# SERVICE BULLETIN

AMERICAN HONDA MOTOR CO., INC. MOTORCYCLE SERVICE DEPARTMENT

## GL1500 CB RADIO SUB-HARNESS

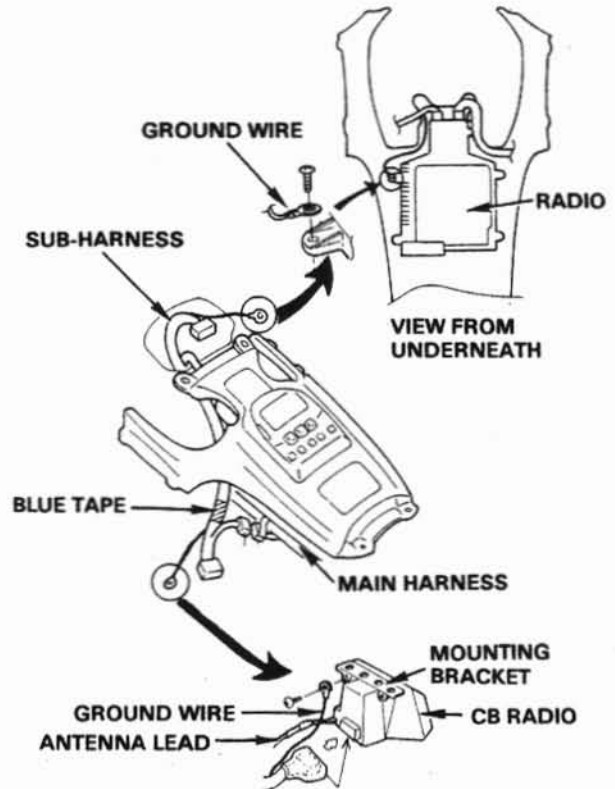
A new CB radio sub-harness is available to improve these conditions. The sub-harness includes an in-line capacitor, resistor and ground wires.

For future identification, remove the left fairing side pocket. A ground wire attached to the CB mounting bracket indicates the new sub-harness (or a CB with serial number 6656 or above) has already been installed. The sub-harness for this repair is also wrapped with blue tape in the area shown above.
